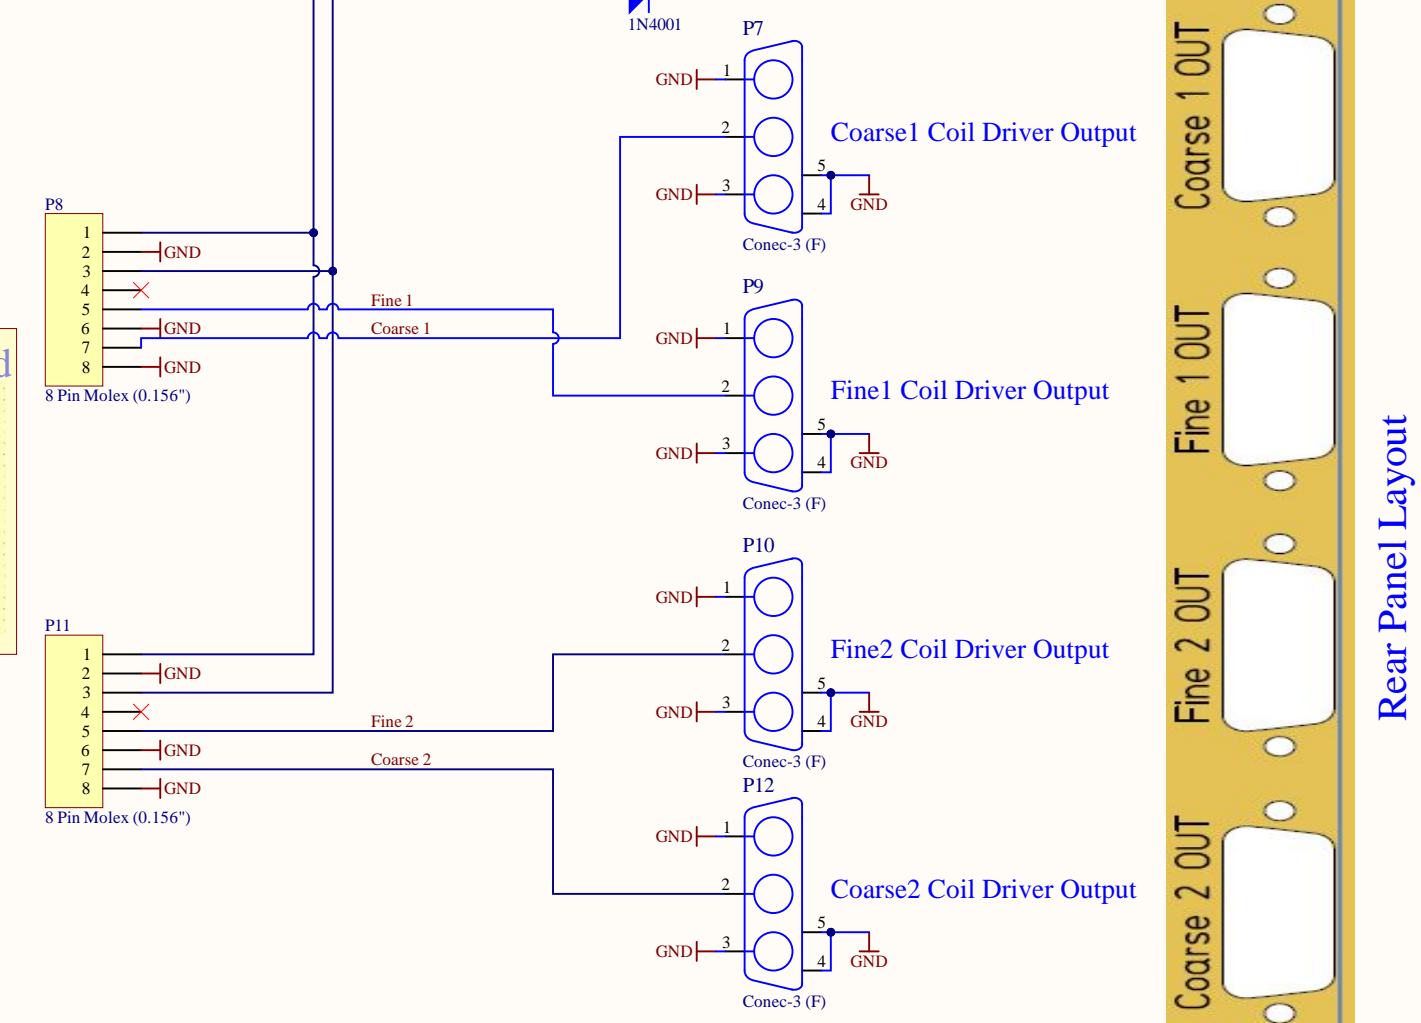
Rev 2;
-Updated the footprint of C3, C5 from 1206 to 2917
-Added the connectors for Fan 1, Fan 2
The 24V to 15V section was updated
